Lake Merritt Station Area Plan

Final Environmental Impact Report

July 2014

Prepared for the **City of Oakland** by

Figure 3.13-2
Contaminated Sites,
Opportunity Sites,
and Schools

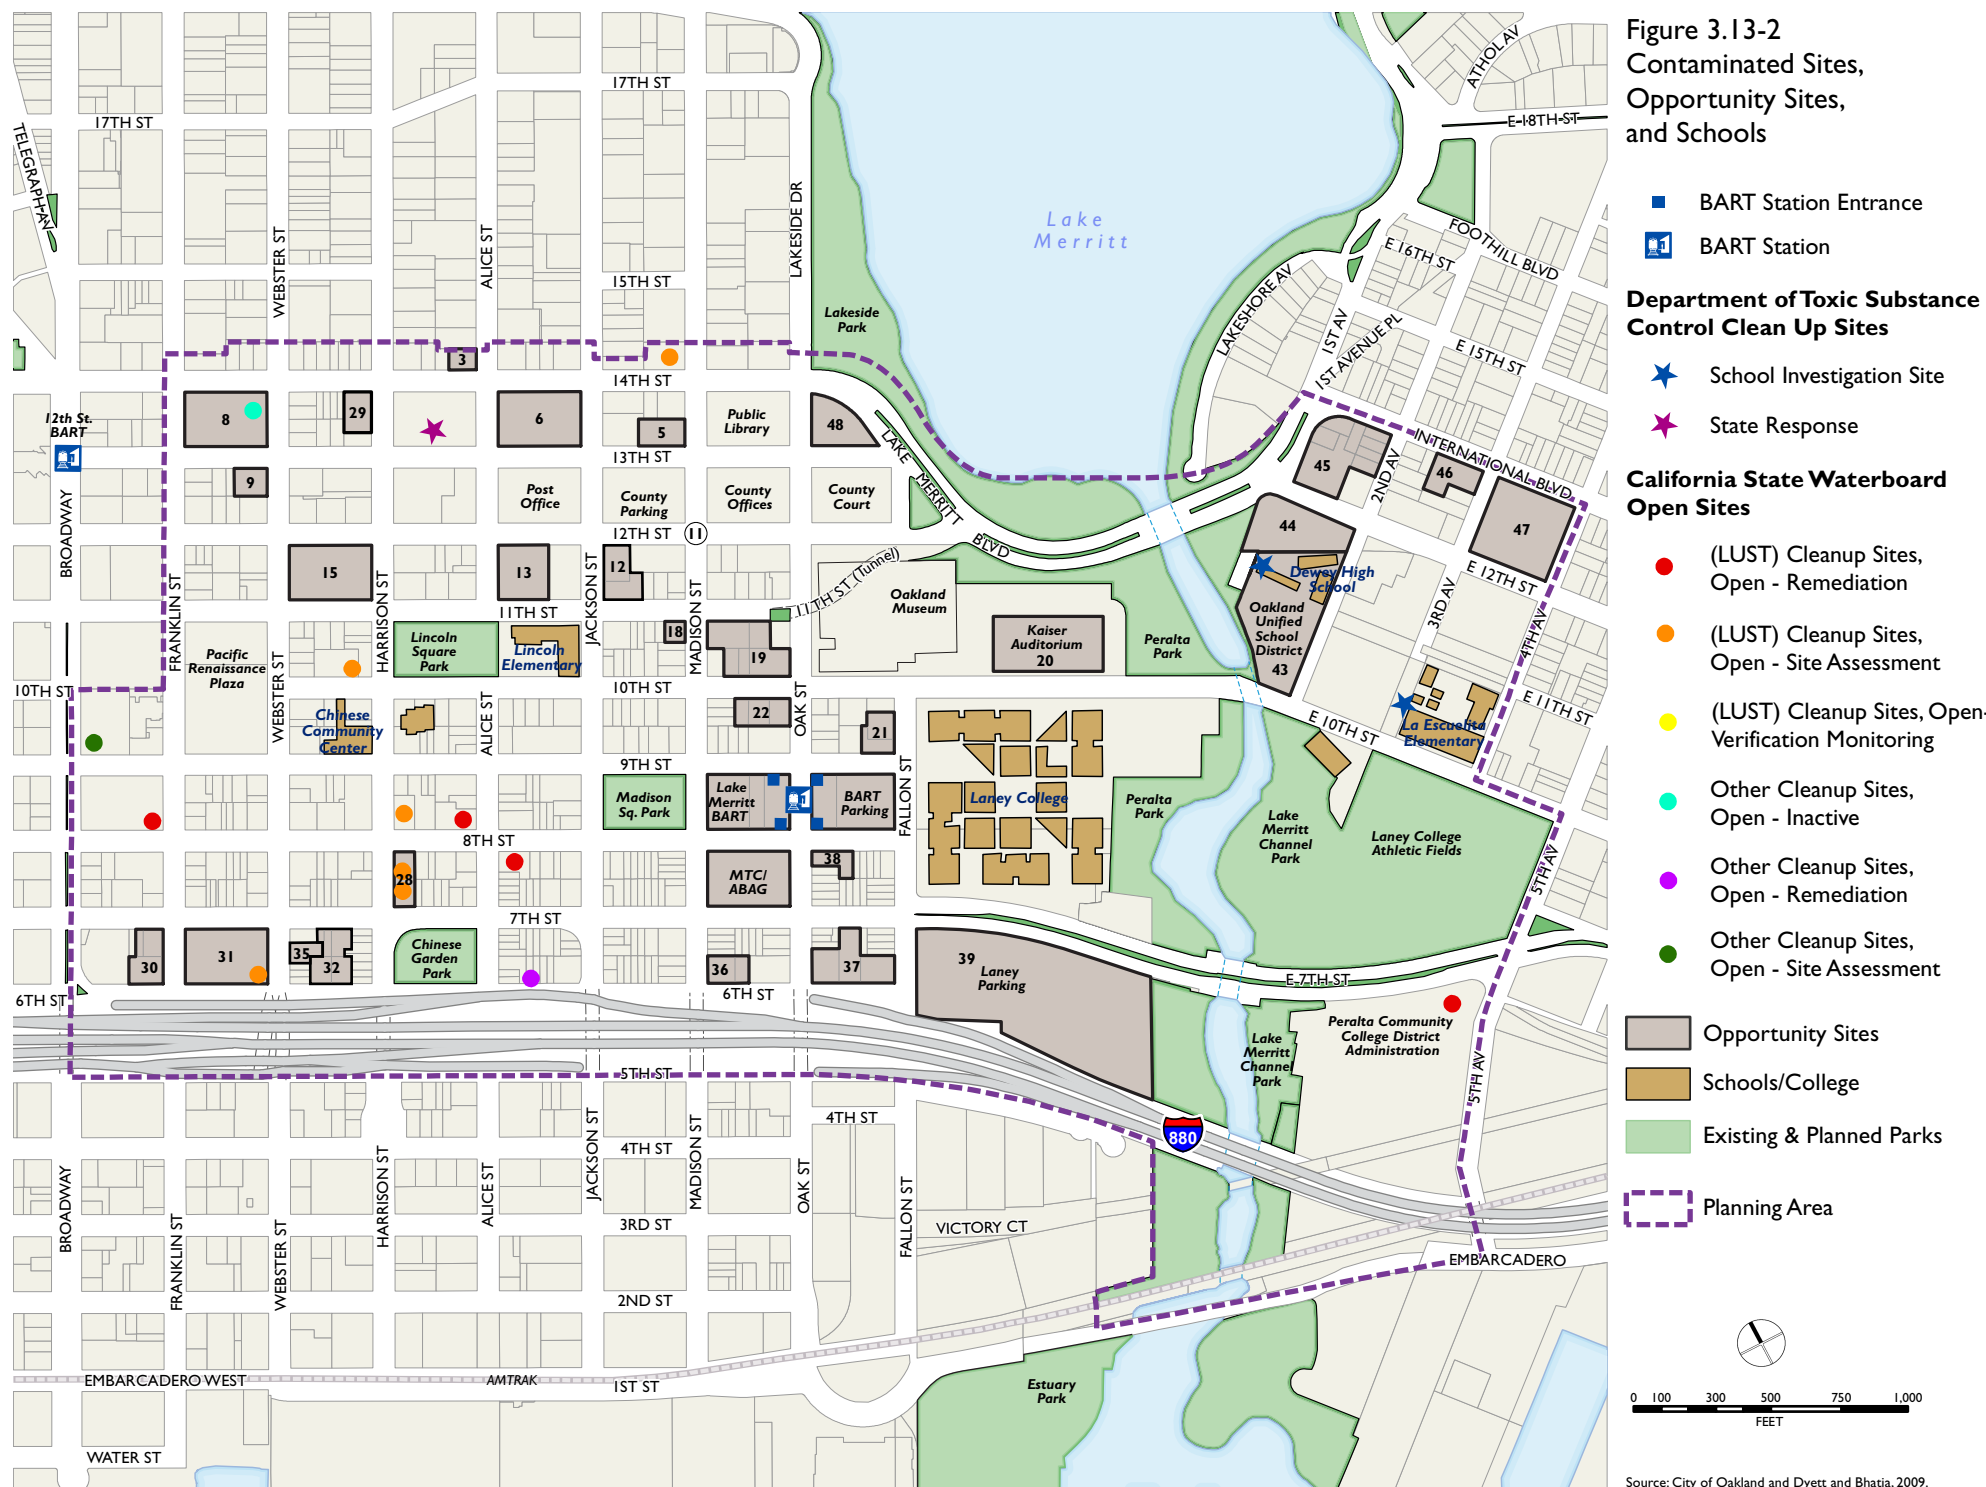
Figure 3.13-2 Contaminated Sites, Opportunity Sites, and Schools, is revised to identify Fire Alarm Building site as Opportunity Site #48.
